TECHNICAL REPORT RS-CR-80-1

**HUMAN ENGINEERING DESIGN CRITERIA
FOR MODERN CONTROL/DISPLAY
COMPONENTS AND STANDARD PARTS**

FINAL REPORT

US Army Human Engineering Laboratory Detachment
Systems Engineering Directorate
US Army Missile Laboratory

FIGURE 12A. ROCKER SWITCHES

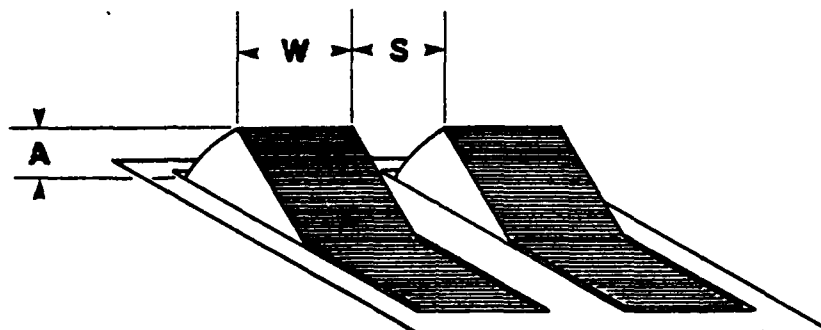
5.4.3.1.7.4 Dimensions, Resistance, Displacement, and Separation — Dimension, resistance, displacement and separation between adjacent edges of rocker switches shall conform to the criteria in Figure 12a.

FIGURE 12B. SLIDE SWITCHES

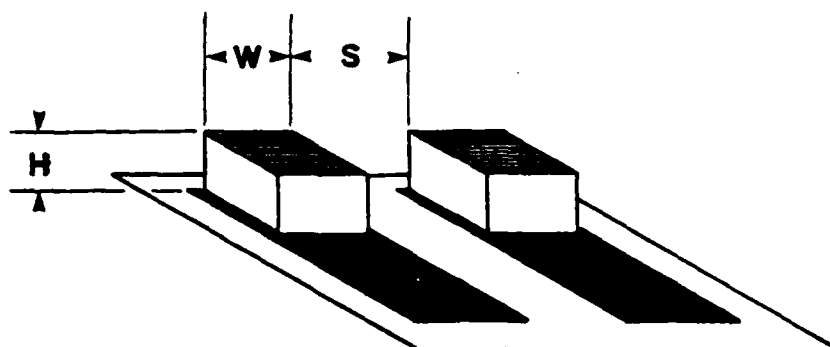
5.4.3.1.11 Slide Switch Controls — Recommended Change: (new paragraph)

5.4.3.1.11.3 Dimensions, Resistance, and Separation — Dimensions, resistance and separation of slide switch handles shall conform to criteria in Figure 12B.

FIGURE 13-A JOYSTICK CONTROL

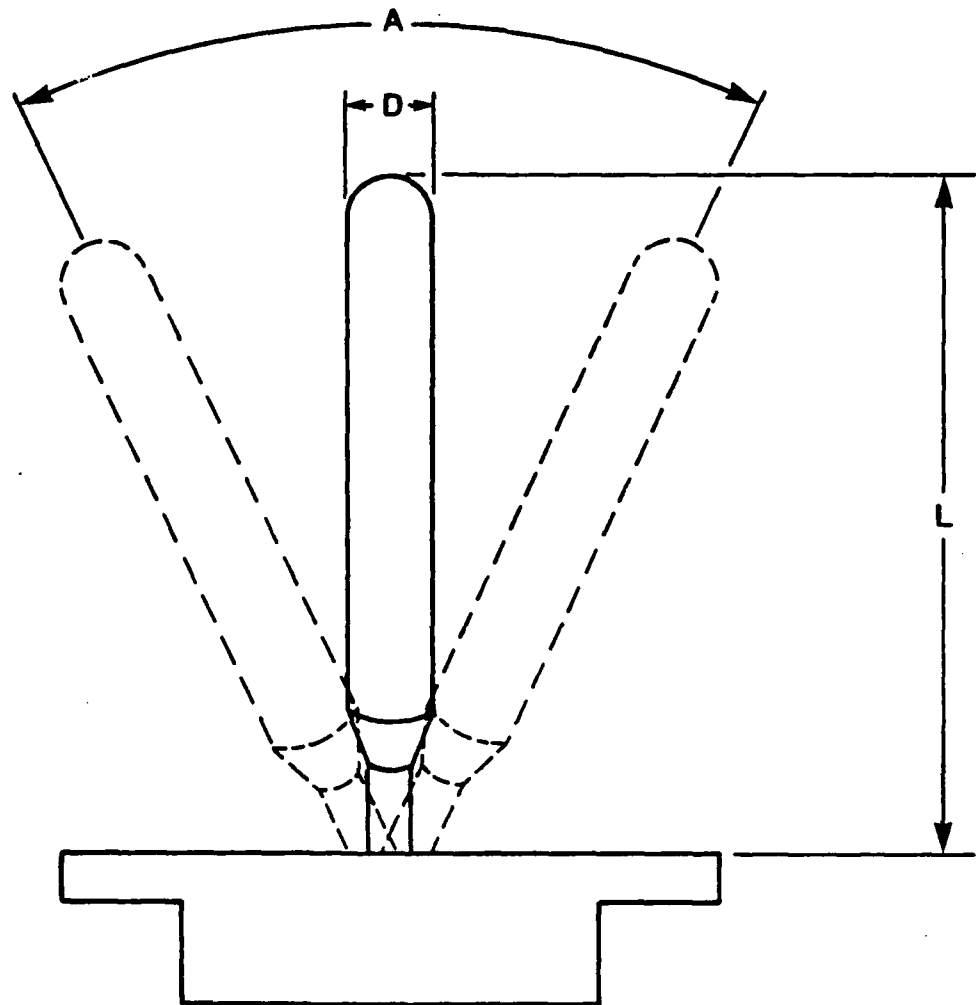
5.4.3.2 Continuous Adjustment Linear Controls — Recommended Change: (new paragraph)

5.4.3.2.3.3 Dimensions, Resistance, and Displacement — Dimensions, resistance and displacement (cone of rotation) for joystick controls shall conform to the criteria in Figure 13a.

FIGURE 12A. ROCKER SWITCHES

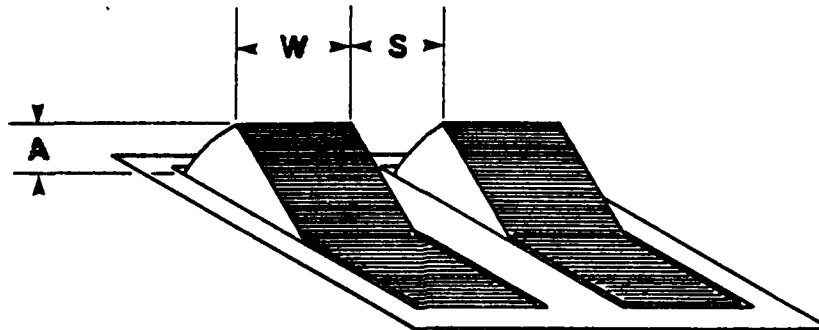
5.4.3.1.7.4 Dimensions, Resistance, Displacement, and Separation — Dimension, resistance, displacement and separation between adjacent edges of rocker switches shall conform to the criteria in Figure 12a.

FIGURE 12B. SLIDE SWITCHES

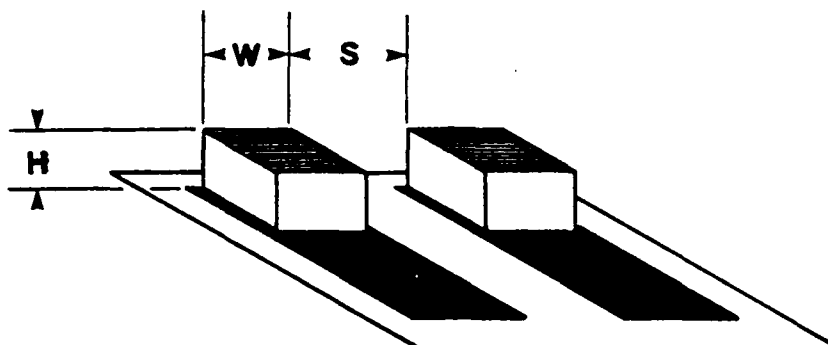
5.4.3.1.11 Slide Switch Controls — Recommended Change: (new paragraph)

5.4.3.1.11.3 Dimensions, Resistance, and Separation — Dimensions, resistance and separation of slide switch handles shall conform to criteria in Figure 12B.

FIGURE 13-A JOYSTICK CONTROL

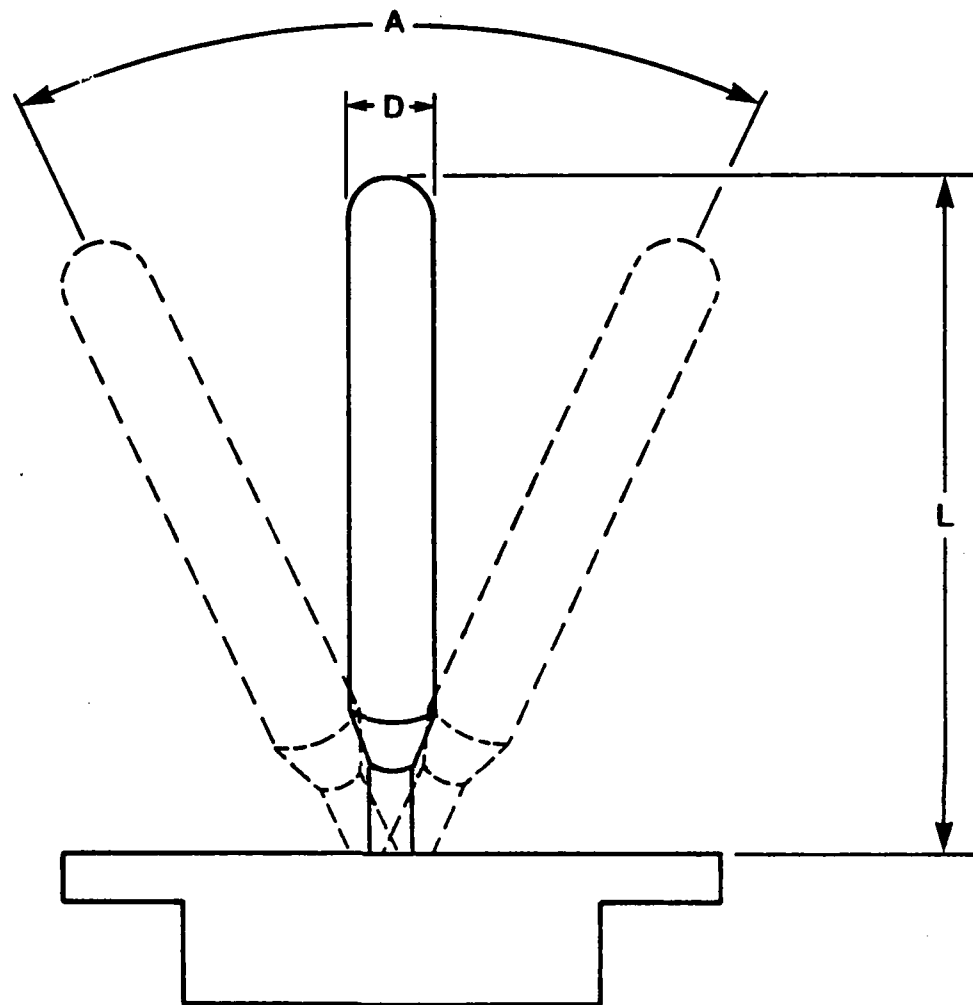
5.4.3.2 Continuous Adjustment Linear Controls — Recommended Change: (new paragraph)

5.4.3.2.3.3 Dimensions, Resistance, and Displacement — Dimensions, resistance and displacement (cone of rotation) for joystick controls shall conform to the criteria in Figure 13a.
